## REMARKS

Amendments to the Drawings:

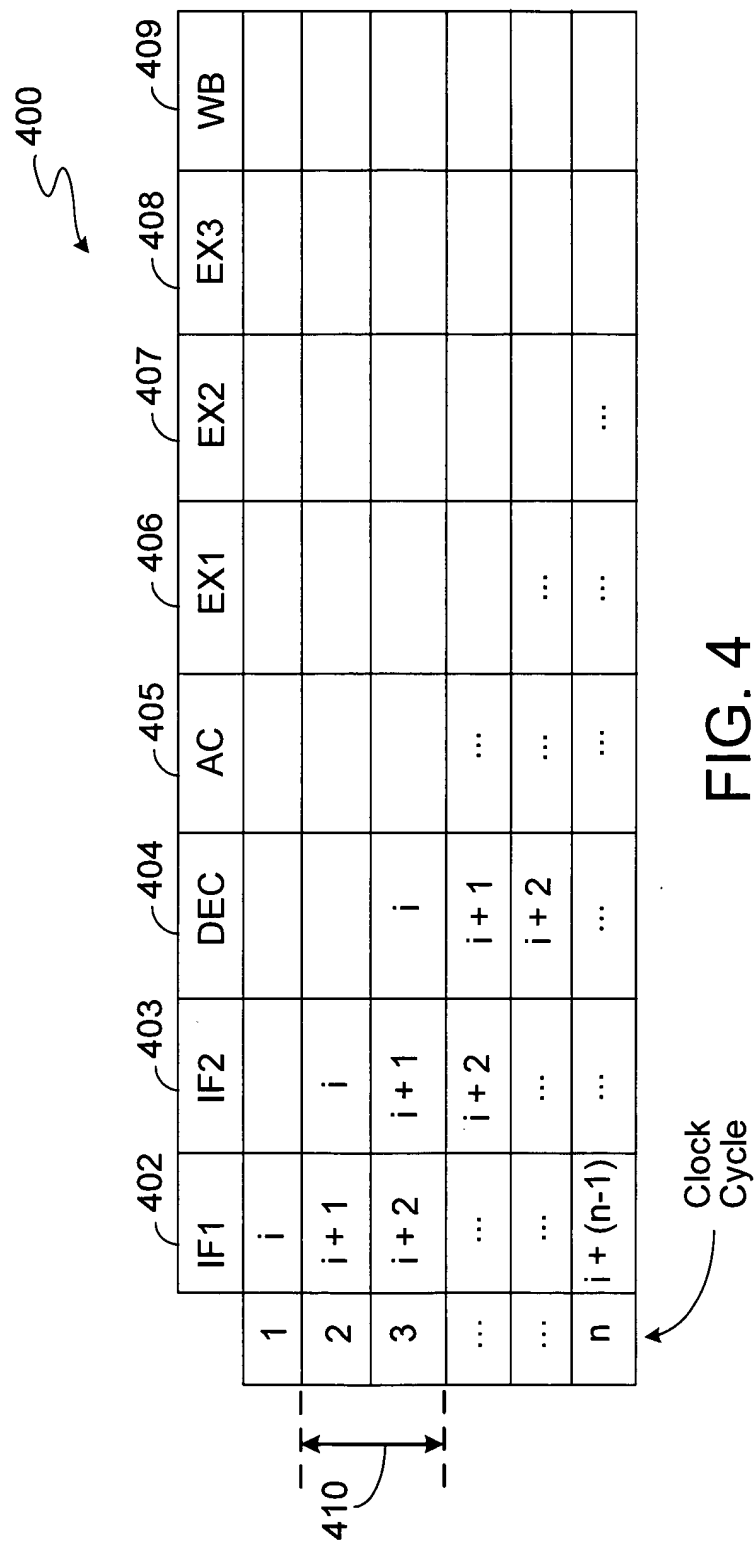
Figure 4, has been amended to show a cache latency of 2 cycles (labeled as 410) to illustrate the example of looking ahead by 2 cycles described in the specification.

FIG. 5

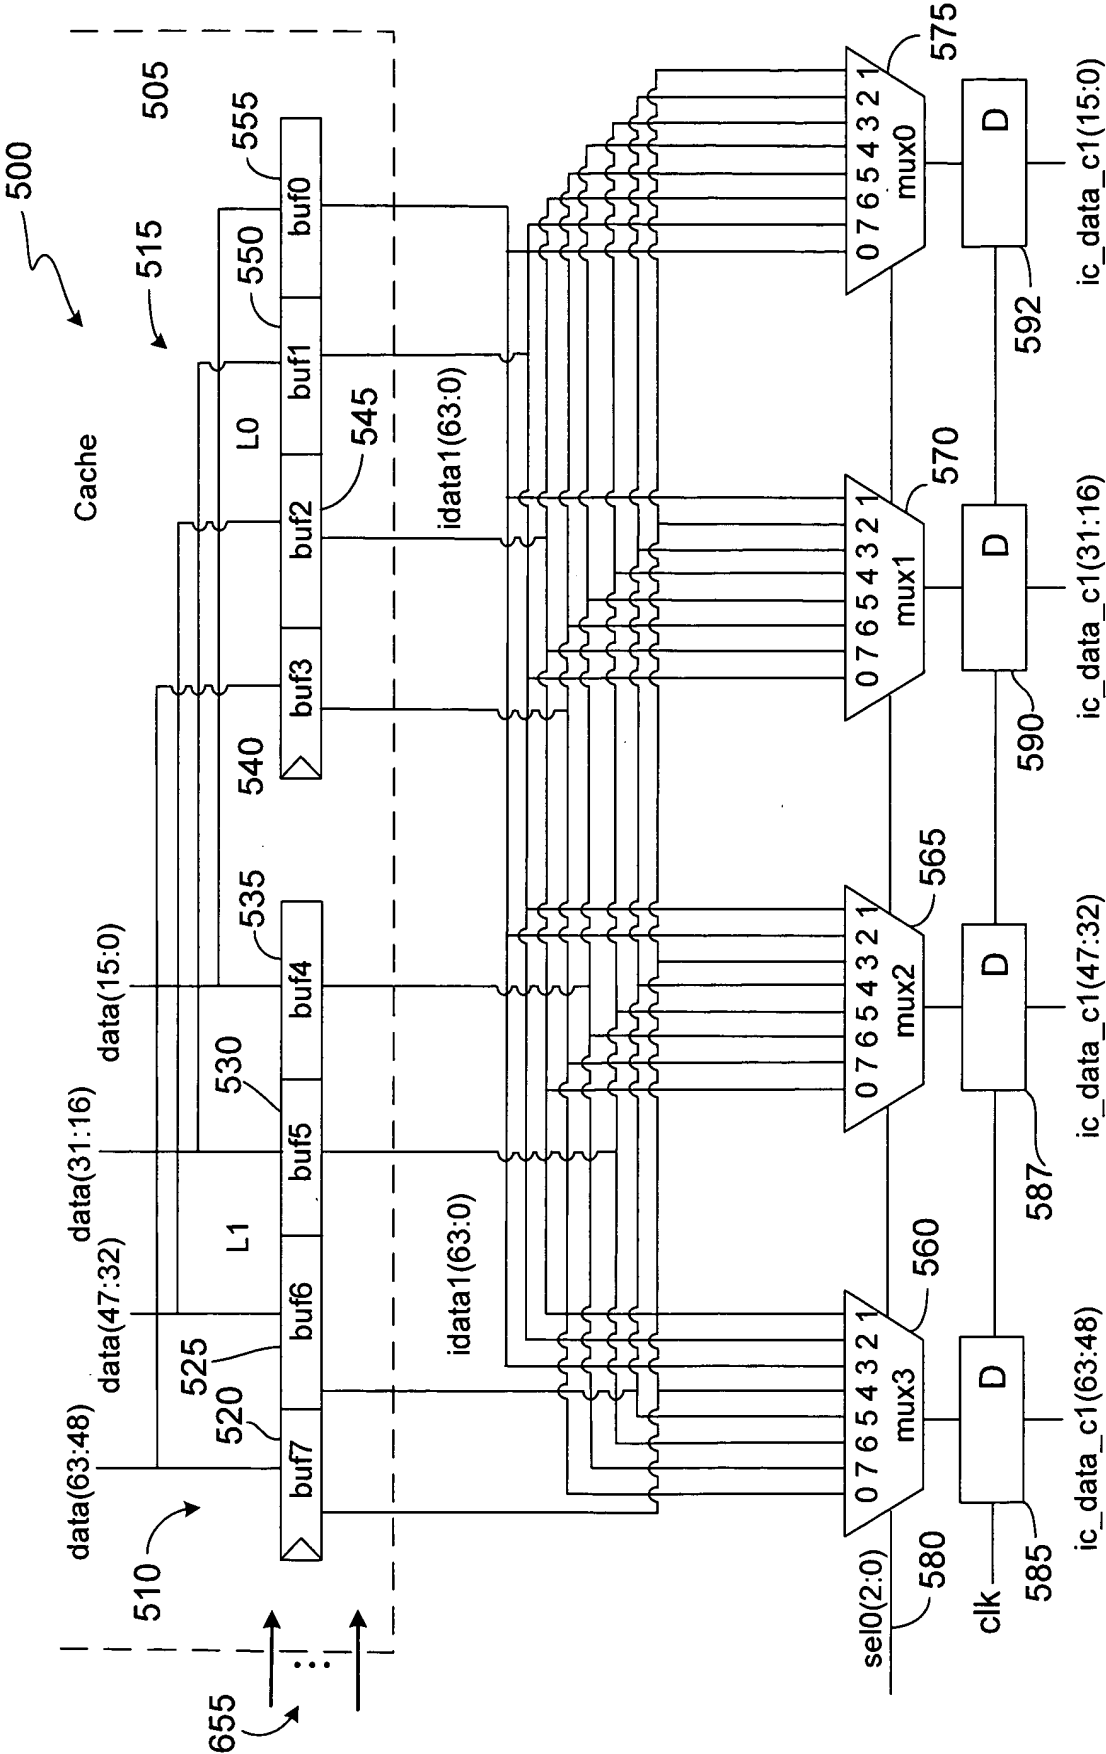
Figures 5 and 6, have been amended to explicitly show pointer signal lines (labeled as 655) used by the transition block 645 to determine the values of the pointers to the buffers 520-555.

FIG. 6

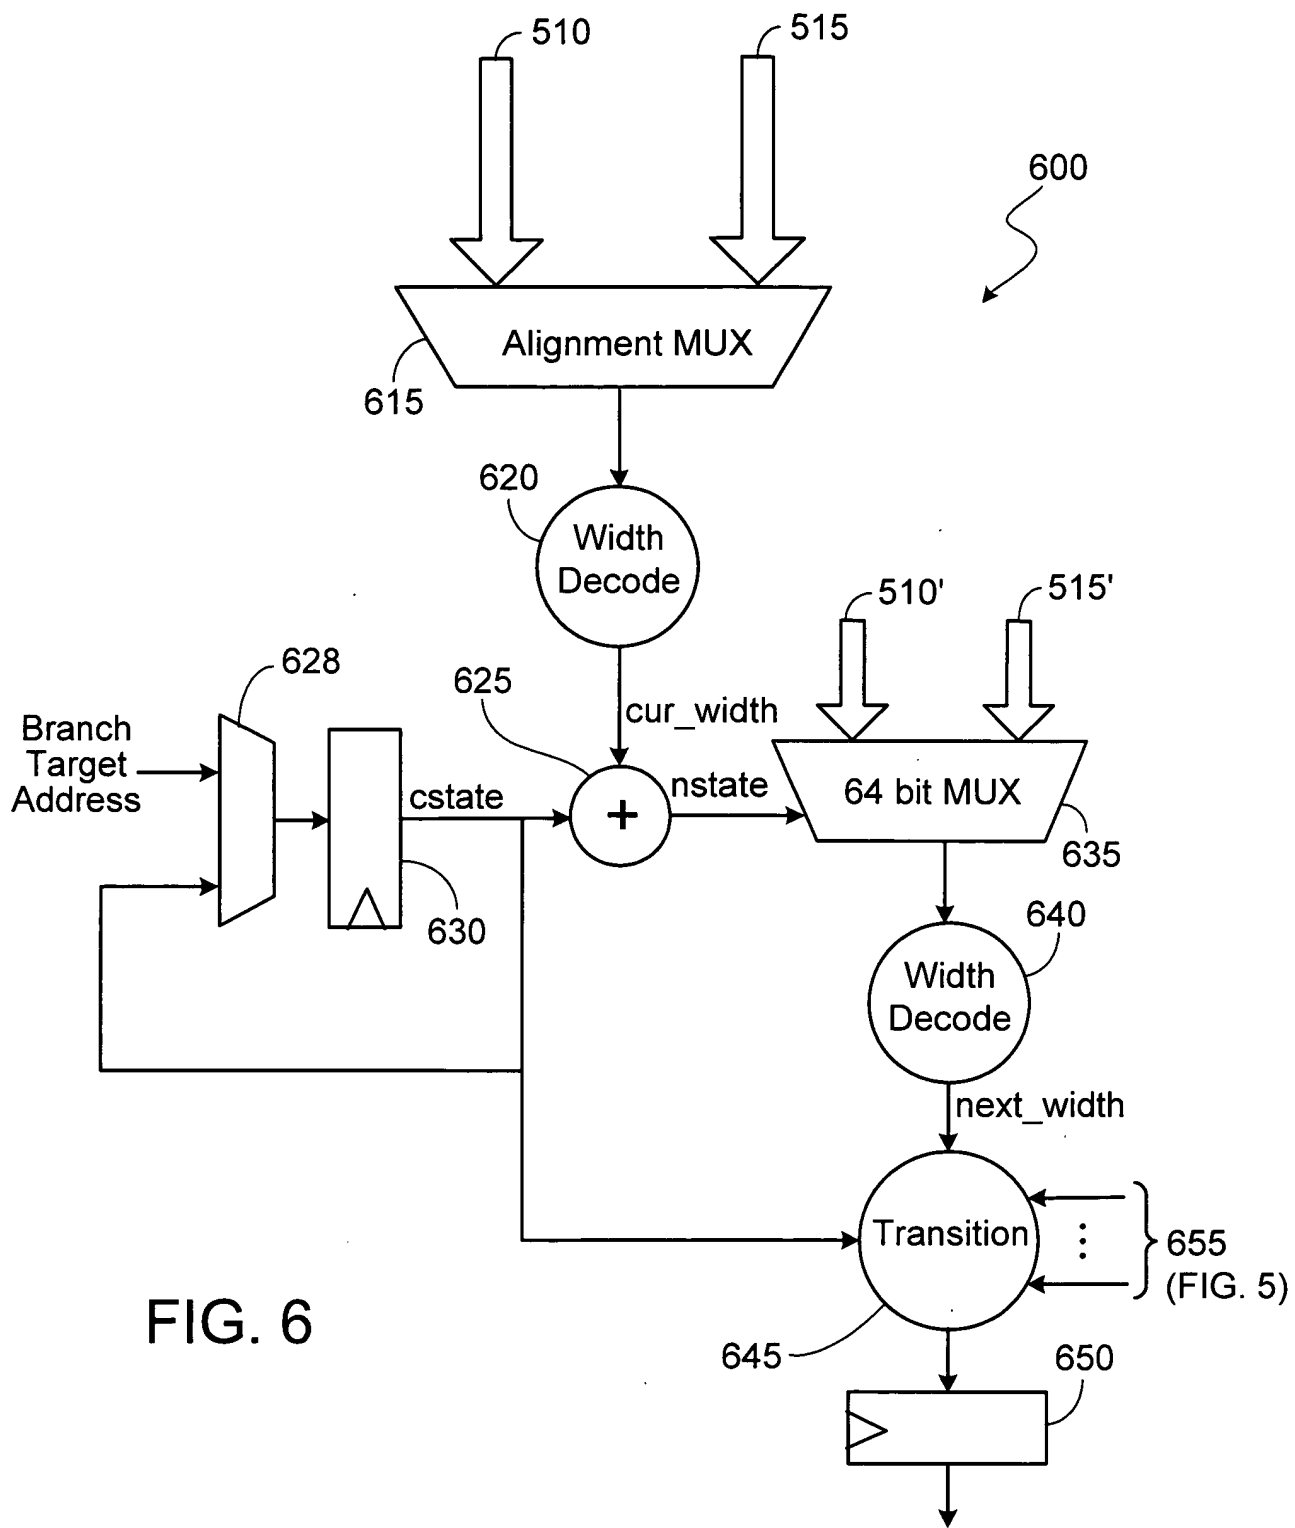
A typographical error in Figure 6 has also been corrected to conform Figure 6 to the description on page 13, lines 3-4 by changing reference numbers 505' and 510' to reference numbers 510' and 515'.
